**World Forum for Harmonization of Vehicle Regulations****Working Party on General Safety Provisions****104<sup>th</sup> session**

**Regulation No. 110 (Specific equipment for CNG)****Proposal for amendments to Regulation No. 110  
(Specific equipment for CNG)****Submitted by the Chair of the Task Force on Liquefied Natural Gas  
vehicles\***

The text reproduced below was prepared by the Chair of the Task Force on Liquefied Natural Gas (LNG) vehicles to introduce type approval provisions for vehicles equipped with LNG propulsion systems. The proposal has been prepared as a new consolidated version (Revision 3) of UN Regulation No. 110. The modifications to the original English text are marked using track changes.

Figure 1  
20 MPa filling unit (receptacle) for M<sub>1</sub> and N<sub>1</sub> vehicles

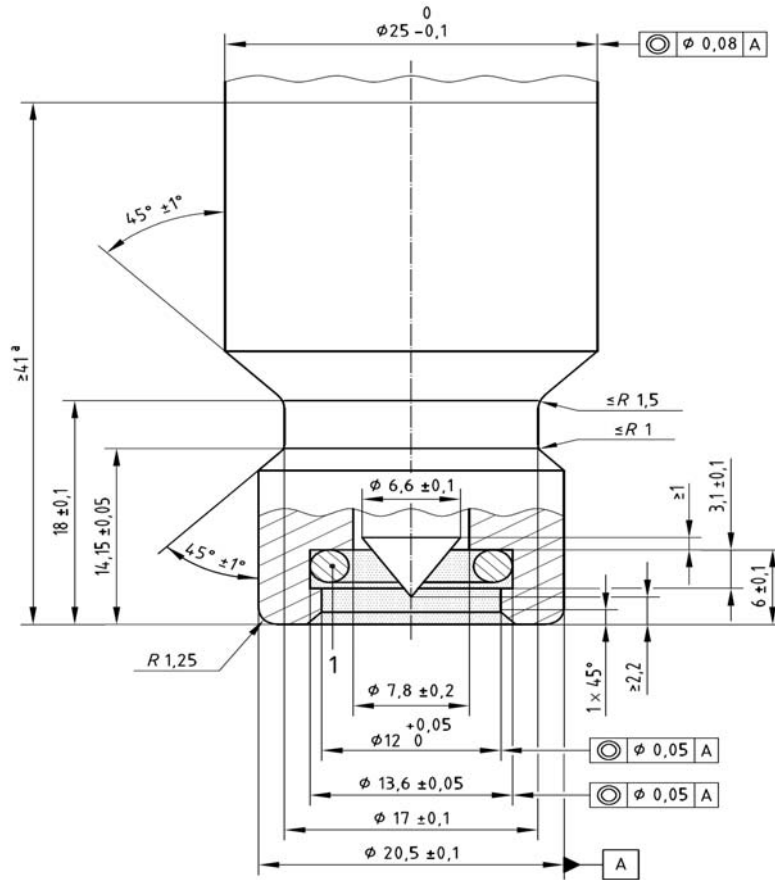
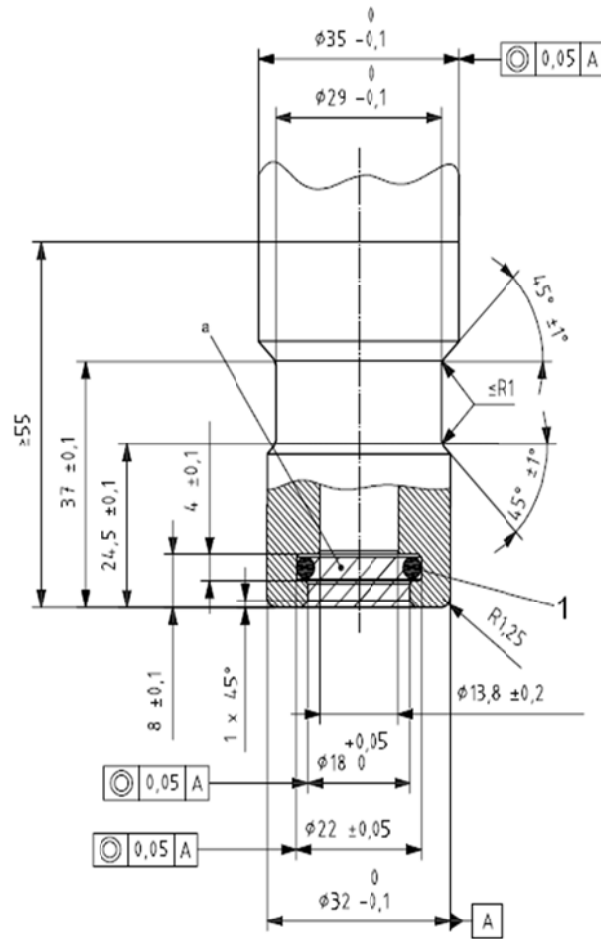
paragraph 1 of Annex 3A of this Regulation. In this case, dimension 25 +0/-1 becomes 24 +0/-1 in Figure 1 and 35 +0/-1 becomes 34+0/-1 in Figure 2.
